To: Town of Cottage Plan Commission
FROM: Mark Roffers, Town Planner
Cc: Kim Banigan, Town Clerk-Treasurer; Nick Bubolz, Town Engineer
DATE: May 19, 2026
RE: Rezoning Request to Facilitate a Prospective Subdivision Plat Along Wittewood Lane

Natural Features and Indicators

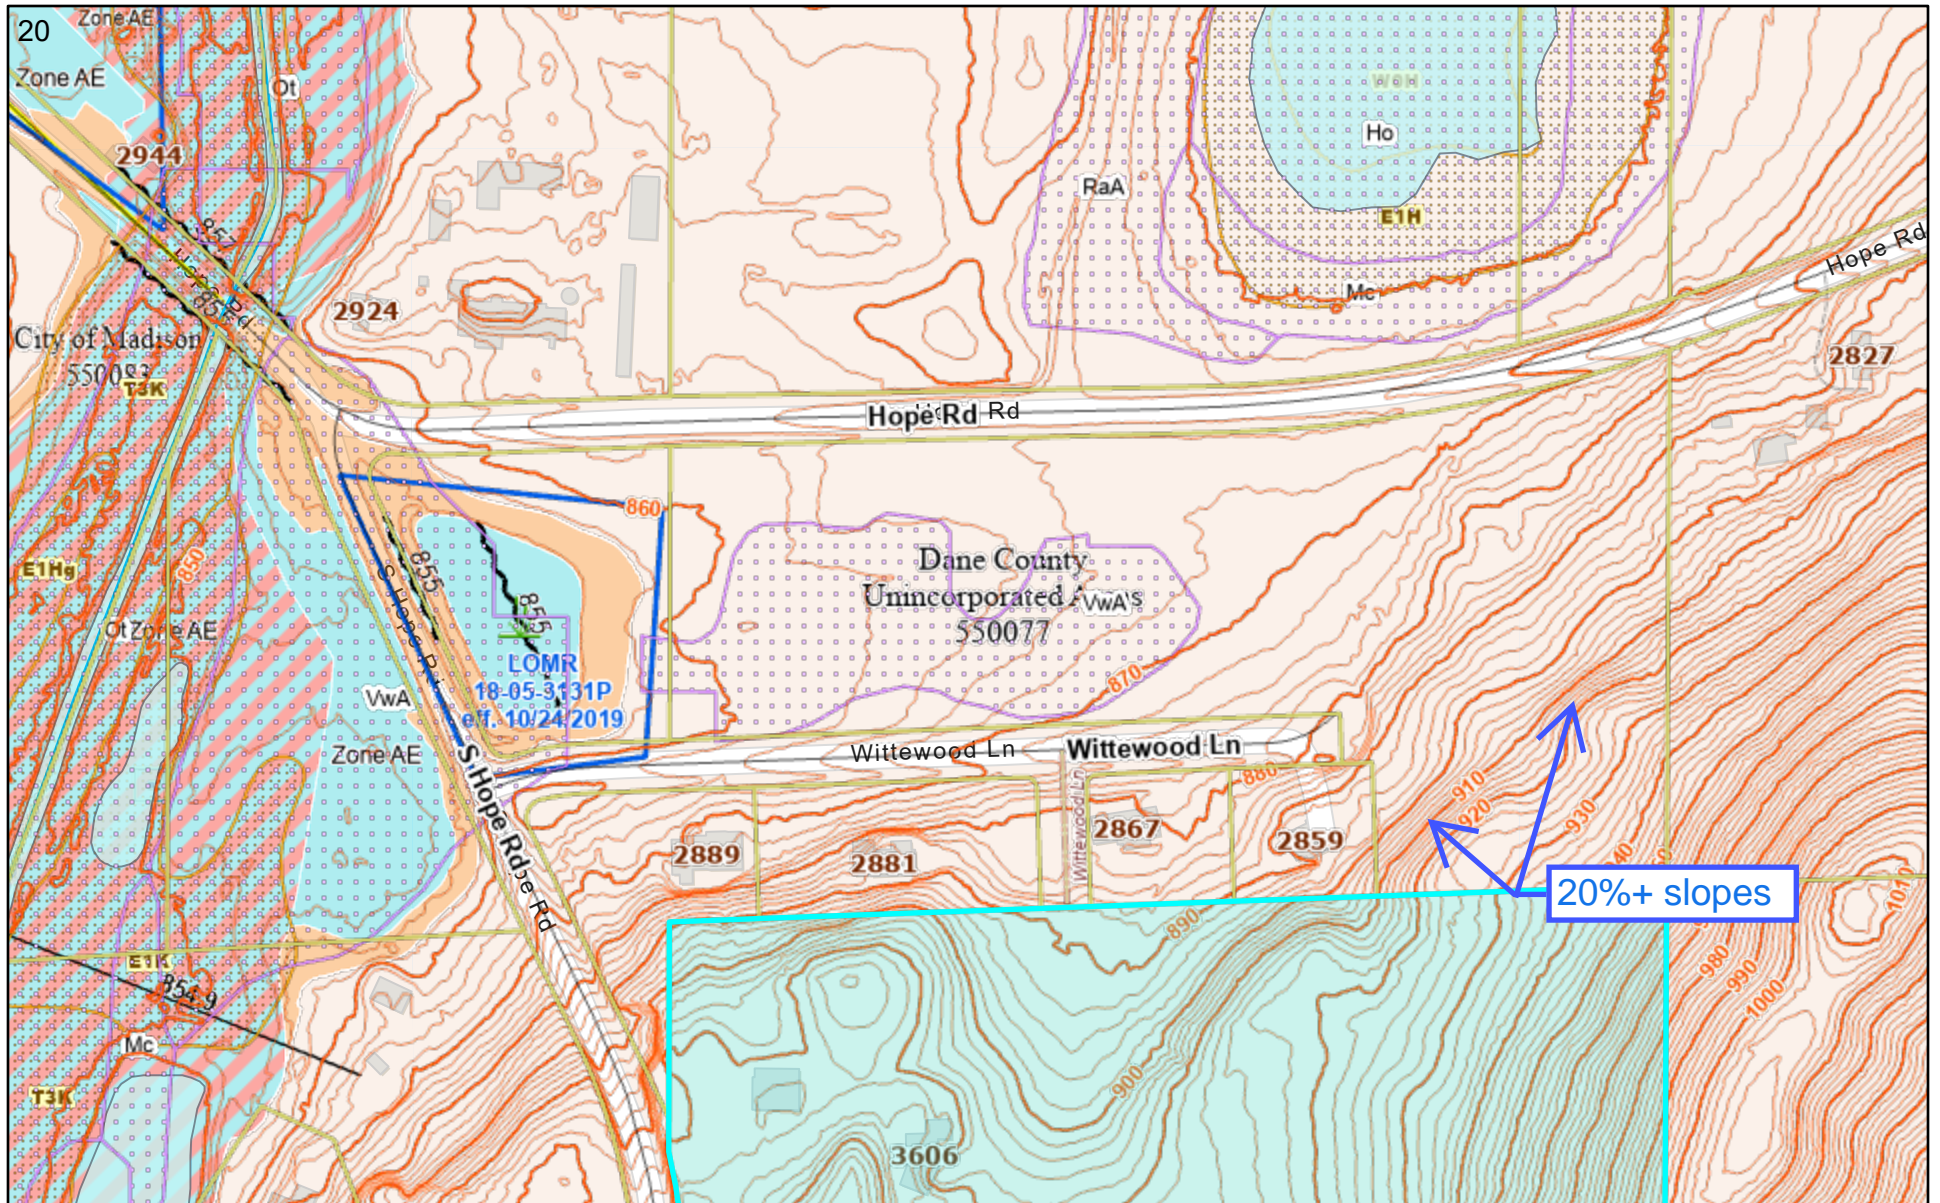
6. The subject site is affected by a few natural limitations, as suggested by the attached Natural Features and Indicators map, and described as follows:

- a. WisDNR indicates dotted areas on the attached map as having wetland indicators, which signals the need for a field wetland delineation to verify. In 2020, Heartland Ecological Group completed a wetland report for the applicants that delineated one 0.86-acre wetland within parcel 0711-301-8000-0, classified as shallow marsh and shrub carr within a constructed stormwater basin. Heartland’s report suggested that this wetland *may* be subject to state and/or federal regulation, and that the report be submitted to the associated agencies for final jurisdictional review and concurrence. It is unclear to me whether the wetland report was submitted and whether the 2020 delineation has expired. Wetland delineations are typically valid for five years.

- b. FEMA designates the aqua shaded areas on the attached Natural Features and Indicators map as 100-year (1%) floodplain (regulated by zoning), with orange areas beyond as 500-year (0.2%) floodplain. While 500-year floodplain is not subject to

zoning regulations, there might be limitations on using such any floodplain area for stormwater management. The applicants are advised to consult with the Dane County Land and Water Conservation Department on possible floodplain/stormwater limitations, even if this area was authorized for stormwater management previously.

- c. There are areas of 20%+ slopes in the southeast corner of the subject site (proposed Lot 10 area). The Town through its Plan advises new development be directed away from 20%+ slopes. The Town's driveway ordinance sets a maximum 12% driveway slope. The applicants should suggest an approach to this challenge. Perhaps establishing a buildable area on the plat that is below (west of) the steep sloped area, and a restriction on disturbance in covenants, are solutions.
